**AGENDA**  
**VILLAGE OF PLEASANT PRAIRIE**  
**PLEASANT PRAIRIE VILLAGE BOARD**  
**PLEASANT PRAIRIE WATER UTILITY**  
**PLEASANT PRAIRIE SEWER UTILITY**  
**Village Hall Auditorium**  
**9915 – 39th Avenue**  
**Pleasant Prairie, WI**  
**August 17, 2015**  
**6:00 p.m.**

Consider **Comprehensive Plan Amendment (Ord. #15-31)** for a for at the request of Jonah Hetland of Bear Development LLC, agent for Creekside PP, LLC, the owner, to amend a portion of the Whittier Creek Neighborhood Plan 32 of Appendix 9-3 for the Bear Development, LLC properties as a result of the proposed development of the remainder of the Creekside Crossing Development.

Consider a **Conceptual Plan** for the request of Jonah Hetland of Bear Development LLC, agent for Creekside PP, LLC, the owner of the vacant properties north of the Creekside Crossing development for the development of 64 single family lots and one (1) two family lot on the remainder of the original Creekside Crossing development area.

**Neighborhood Plan Map 32-a  
Whittier Creek Neighborhood**  
Amendment adopted by Plan Commission Resolution #15-15 and Village Board  
Ordinance #15-31

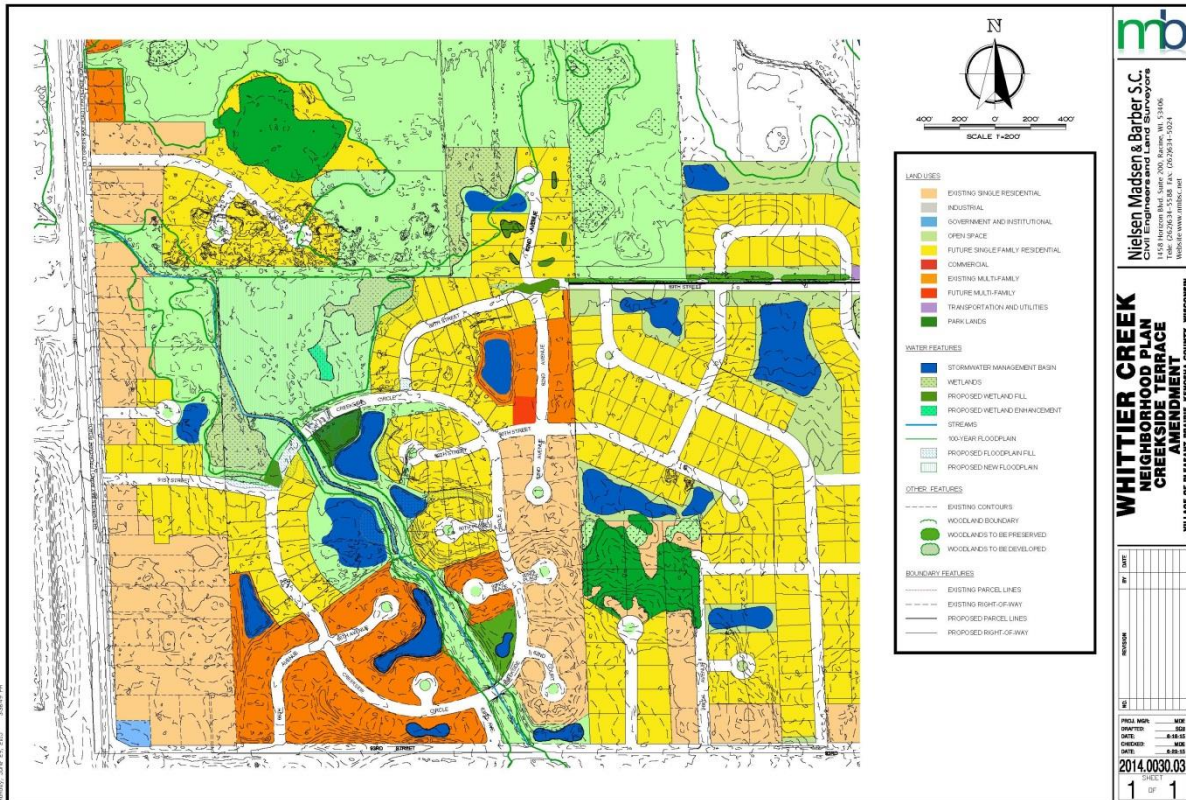
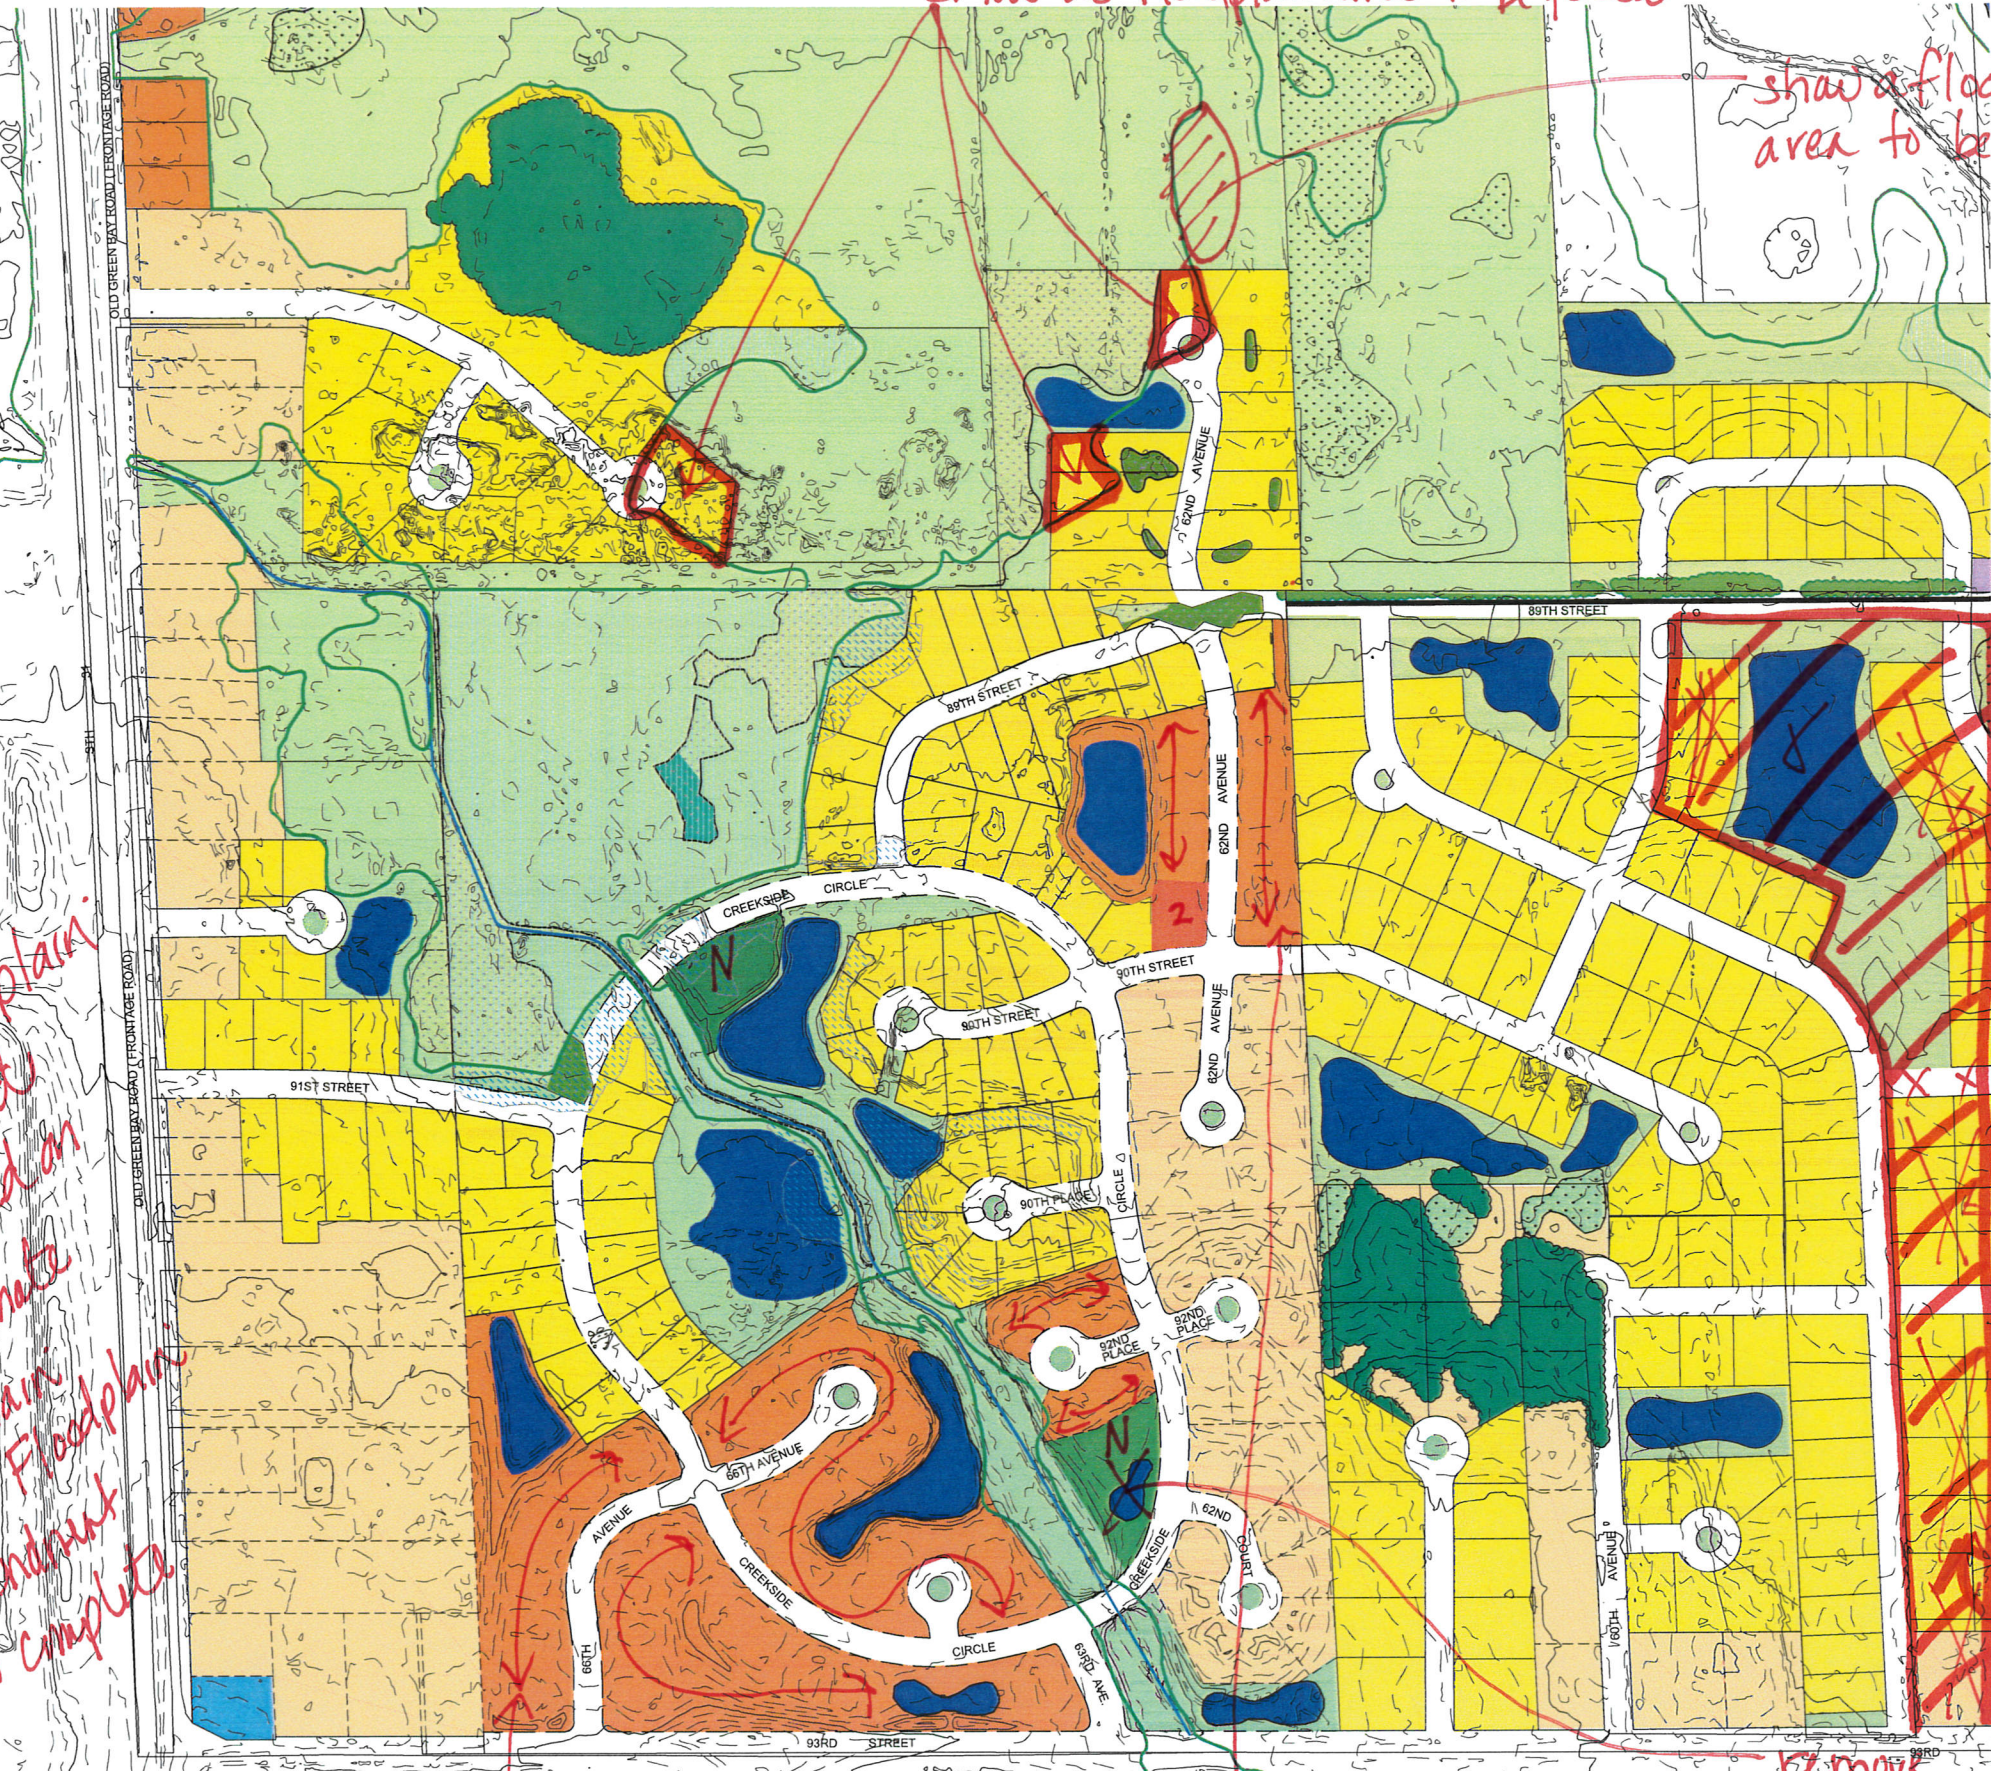
**This Illustration shall be changed to incorporate the changes as  
recommended by the Plan Commission in Village Staff Report dated August  
10, 2015.**

Show floodplain in Creekside Dev. based on the ultimate floodplain one Floodplain amendment is complete

show as floodplain area to be filled

show a flood plain area to be created
